**BID #10-088 YOUTH SERVICES CENTER
EL PASO, TEXAS**

ADDENDUM NUMBER THREE

January 3, 2011

YOUTH SERVICES CENTER
 6400 DELTA DRIVE, EL PASO, TEXAS
ADDENDUM #3

AD1.01
RE:AC1.01
 SHEET 01 OF 11

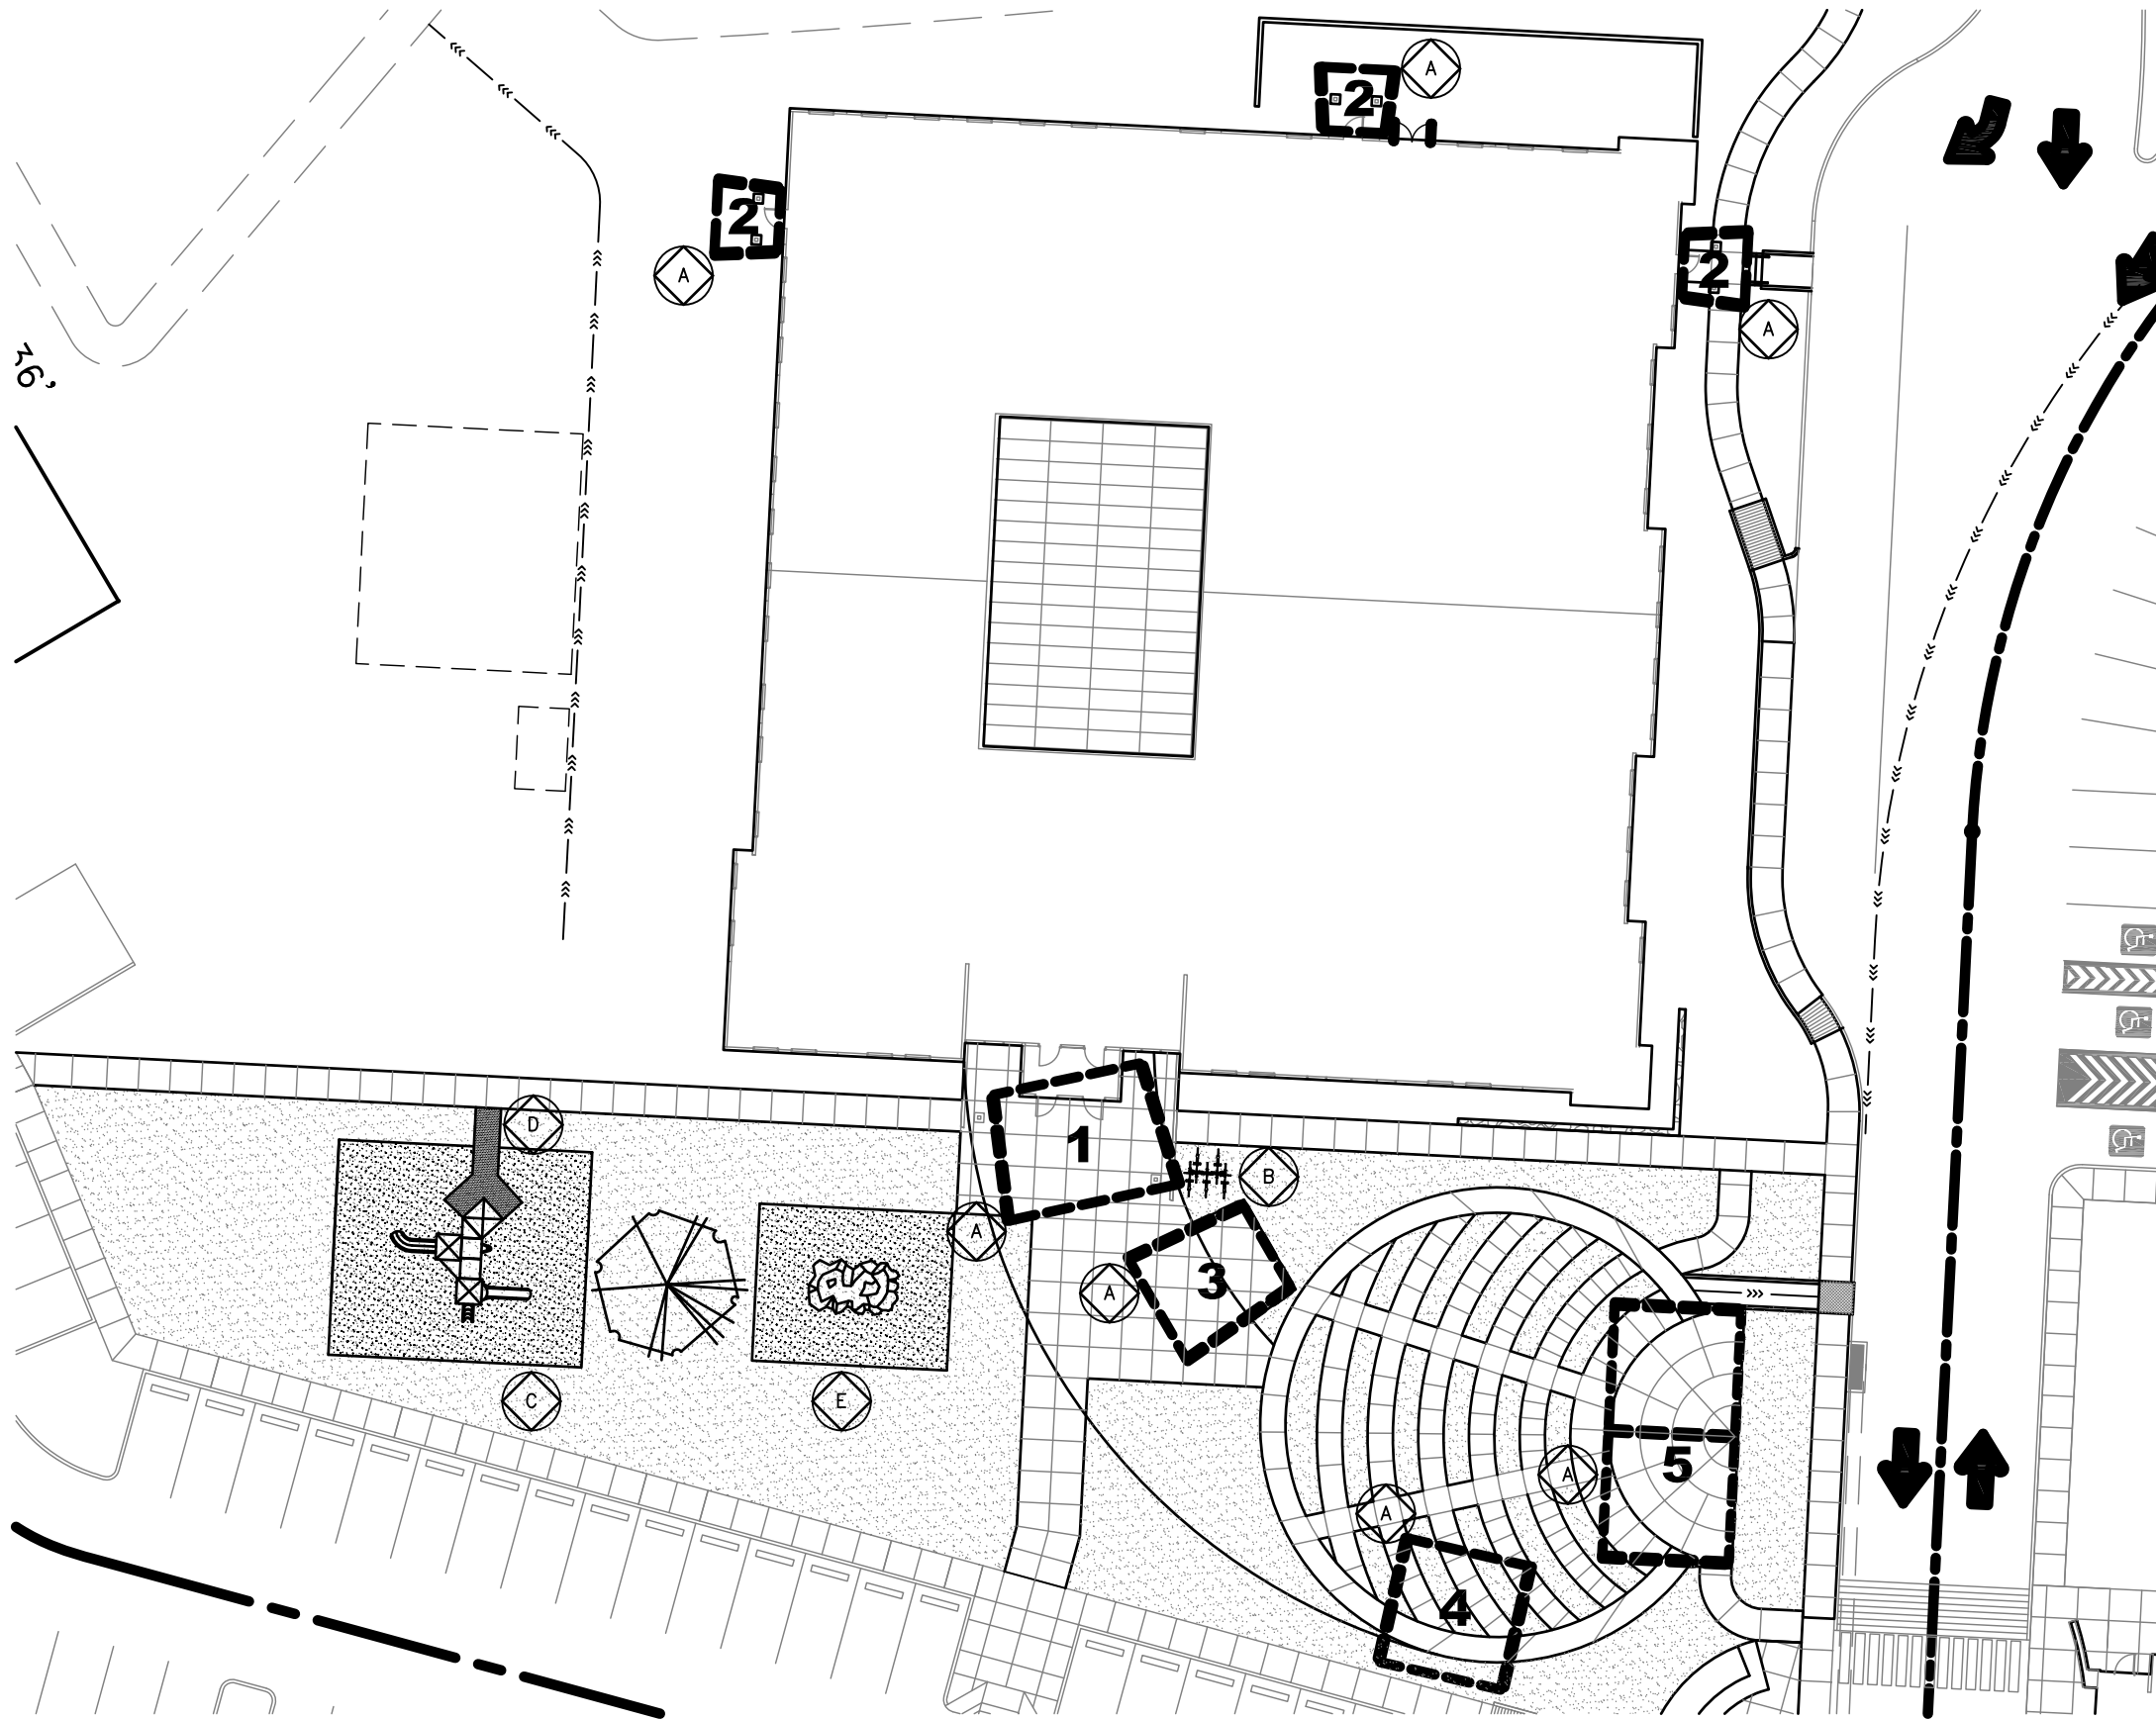
1. Response to questions provided with this addendum.
 - a. **Location / quantity of bike racks:** Provide one 5-unit bicycle rack as per attached drawing AD1.01.

- b. **Detail of shade structures:** See attached drawings AD1.01, AD1.02, AD1.03 and specifications Section 107316: Shade Canopies
 - c. **Playground layout / details:** See attached drawing AD1.01 for location and specifications Section 11 68 13 including change described below.

- (A) PREFABRICATED CANOPIES
RE: AD1.02 & AD1.03
- (B) BICYCLE RACK
DERO MODEL RR2H OR
APPROVED EQUAL.
INGROUND MOUNT
- (C) PLAYGROUND EQUIPMENT
LANDSCAPE STRUCTURES
DESIGN 306, PHASE 1.
PROVIDE A 40' x 34' FALL
ZONE COMPRISED OF 12"
DEPTH WOOD MULCH. WITH
BEVELED PLASTIC EDGING
AROUND PERIMETER.
- (D) HANDICAP ACCESSIBLE WALK
TO PLAY STRUCTURE..
PROVIDE POURED IN PLACE
SAFETY SURFACING ONCE
INSIDE FALL ZONE
- (E) LANDSCAPE STRUCTURES
8' x 14' CLIMBING ROCK.
PROVIDE FALL ZONE TO BE
COMPRISED OF A 12" DEPTH
OF WOOD MULCH. WITH
BEVELED PLASTIC EDGING
AROUND PERIMETER.

AD1.02
RE:AD1.01

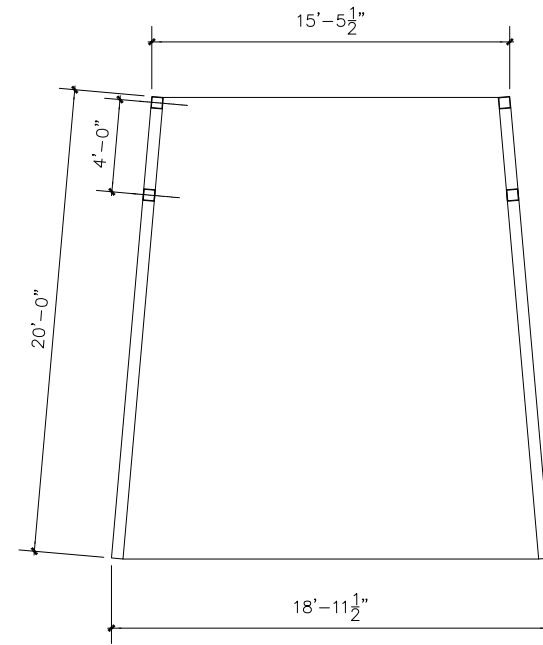
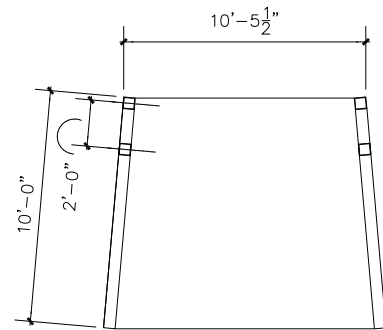
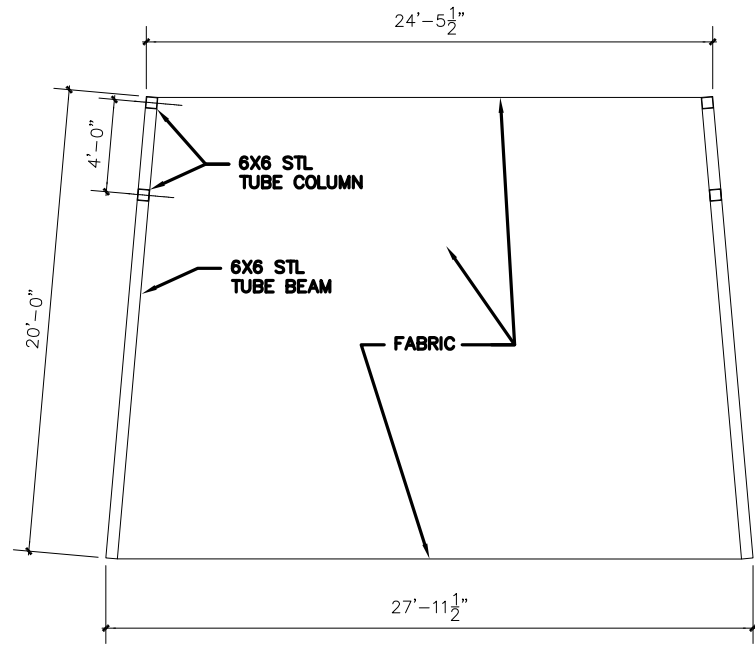
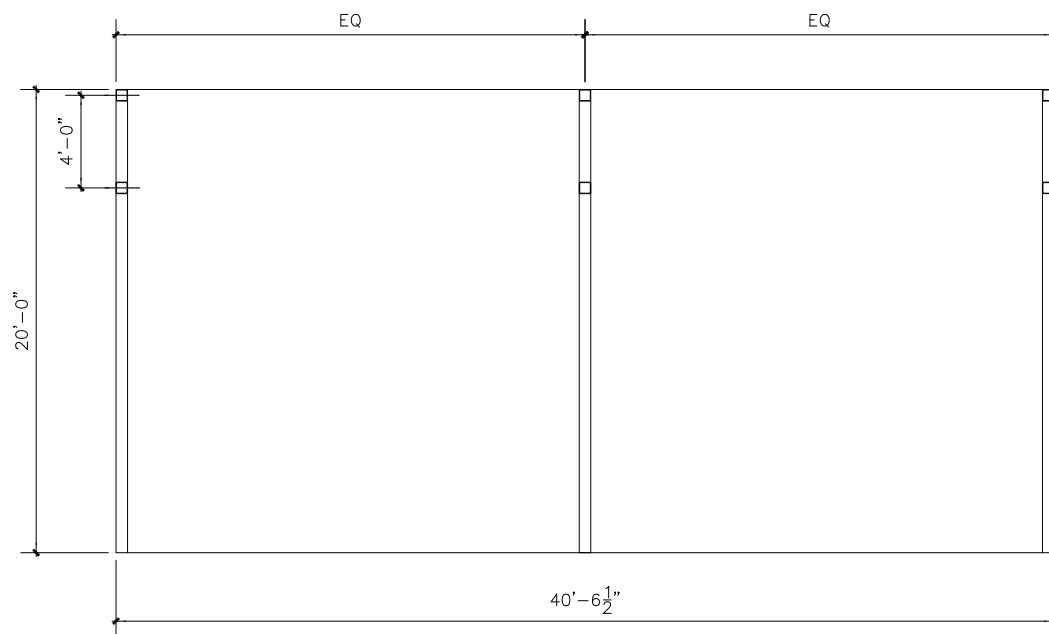
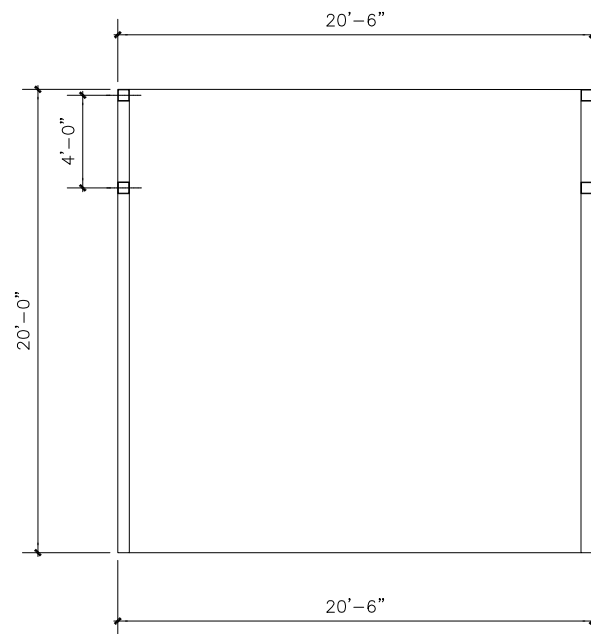
- A. Supplemental Drawings AD1.01, AD1.02 and AD1.03 for shade canopies.
- B. Supplemental Drawings AD1.01 for bike racks.
- C. Supplemental Drawings AD1.01 for playground equipment location and details.
- D. Supplemental Drawings AD1.04 for Kiosk.
- E. Supplemental Drawings AD1.05 for Etched Glazing.
- F. Supplemental Drawings AD1.06 for spandrel panel information (SP1 / SP2).
- G. Supplemental Drawings AD1.07 to AD1.11 for additional information on exterior curtain wall glazing and sunshade awnings.
- H. Supplemental Drawings AD1.12 for additional information on base bid interior atrium finish work, planters, plant material, irrigation and playground equipment.
- I. Plumbing: Sheet P1.01 – Replace the “ELECTRIC WATER HEATER SCHEDULE” with the following:

01 INFORMATION KIOSK
SCALE: 1/2" = 1'-0"

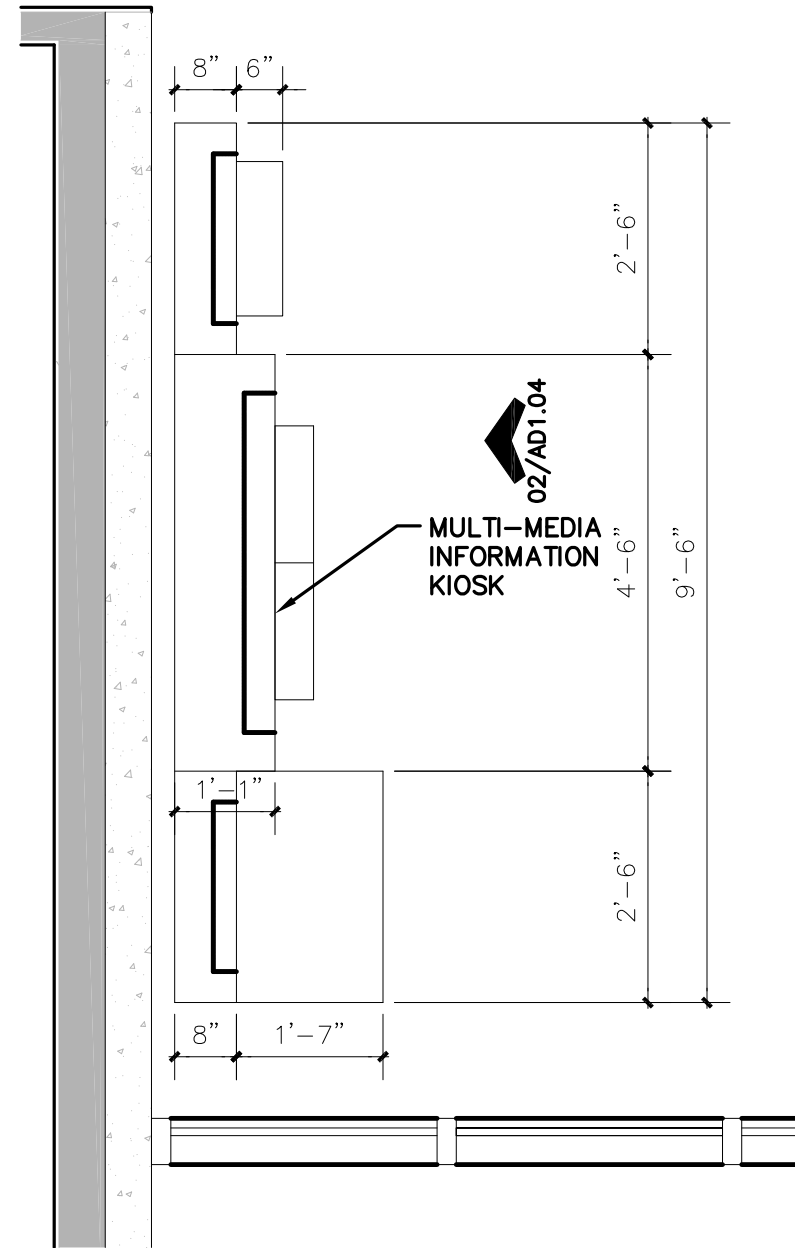
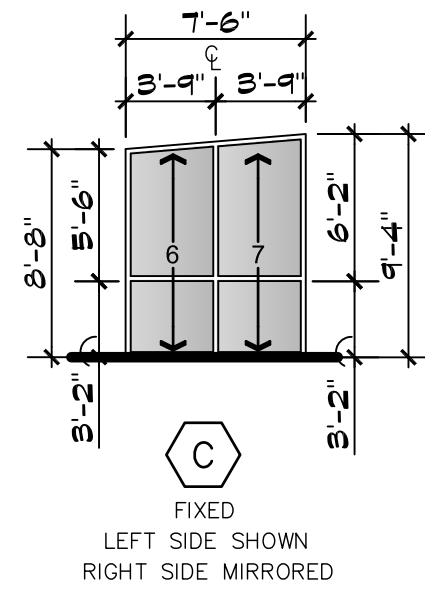
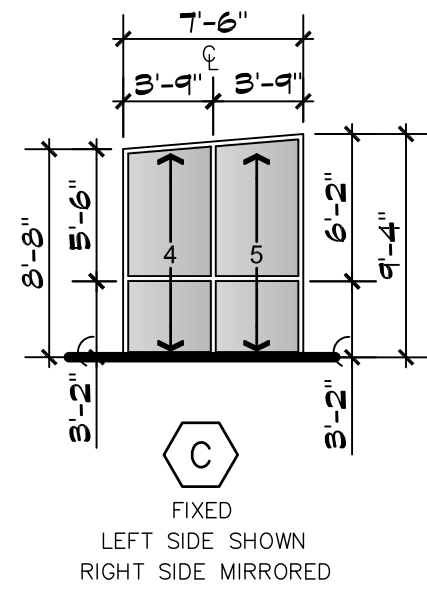
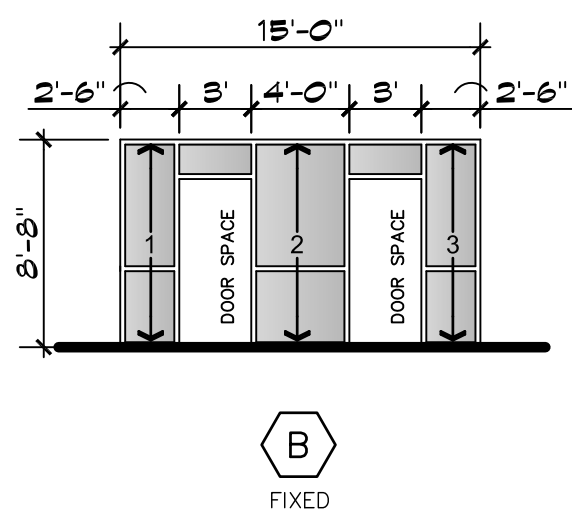
- g. **Specifications on Kiosk:** See attached Supplemental Drawing Sht AD1.04.
 - h. **Details on Alternate #6 – Etched Glazing.** See attached Supplemental Drawing AD1.05. In lieu of 1-inch glazing, provide translucent panel 1-inch thick Chroma by 3 Form or an approved equal. Etched image detail shown on Sheet AD1.05 is for general intent only. Digital format images will be provided by the architect.

01 ALTERNATE #6 ETCHED GLAZING
SCALE: NTS

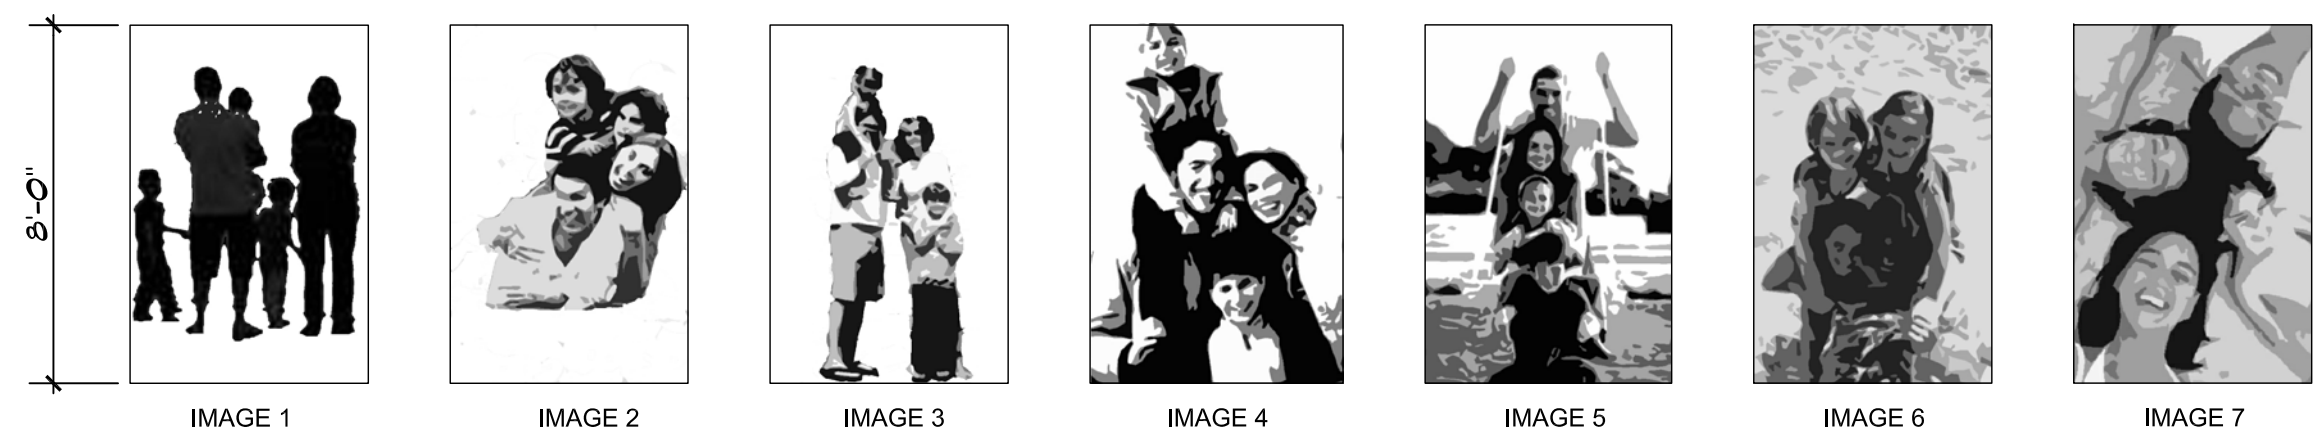
NOTE: IN LIEU OF 1" LOW E GLAZING, PROVIDE 1" THICK TRANSLUCENT PANELS: "CHROMA" BY 3FORM (CADRE DESIGN CONSULTANTS, GERALD FORNELL 505.466.2612) OR APPROVED EQUAL. PROVIDE LASER ETCH WITH A FROSTED FINISH. IMAGES SHOWN ARE FOR GENERAL INTENT; FINAL DIGITAL FORMAT WILL BE COORDINATED WITH SUPPLIER AND PROVIDED BY ARCHITECT.
